March 2026, Field Action Reference: 97125289H-1-FA.

Brady SMR6 Correction for ACCOLADE™ Family and DR-EL and CRT-P population expansion

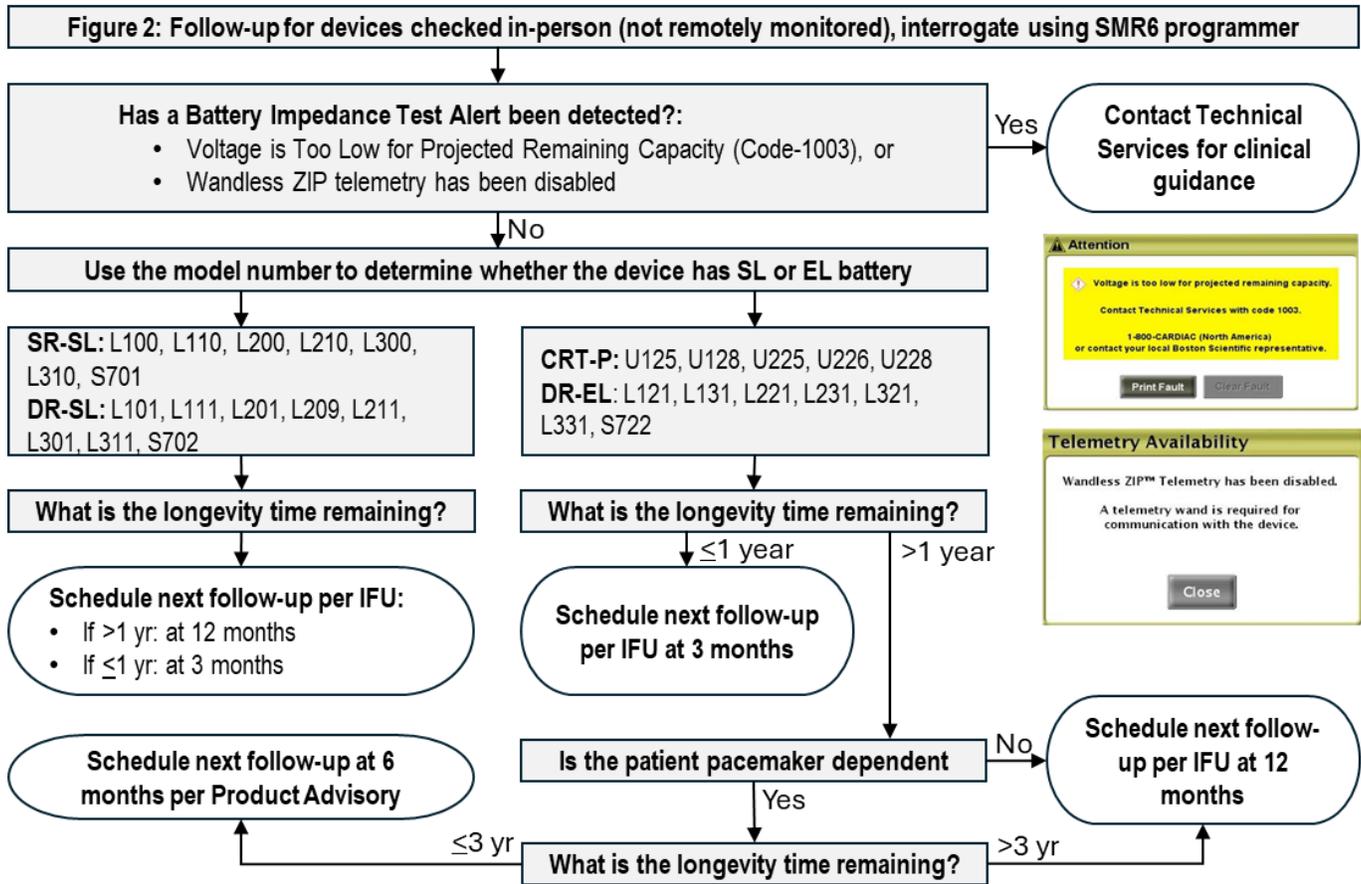
- Prophylactic replacement before confirming high battery impedance is not recommended.
- Remote follow-up interval is unchanged from the Instructions For Use (IFU) and most devices followed in-person may resume normal follow-up interval after being upgraded to SMR6 (see Figure 1 and 2).

- Follow devices using the applicable flow chart below, based on the remote monitoring status (Figure 1 and 2).
- Update the medical record for each patient with an affected device (see Appendix A) by appending this letter to ensure continuous awareness throughout the device’s remaining service life.
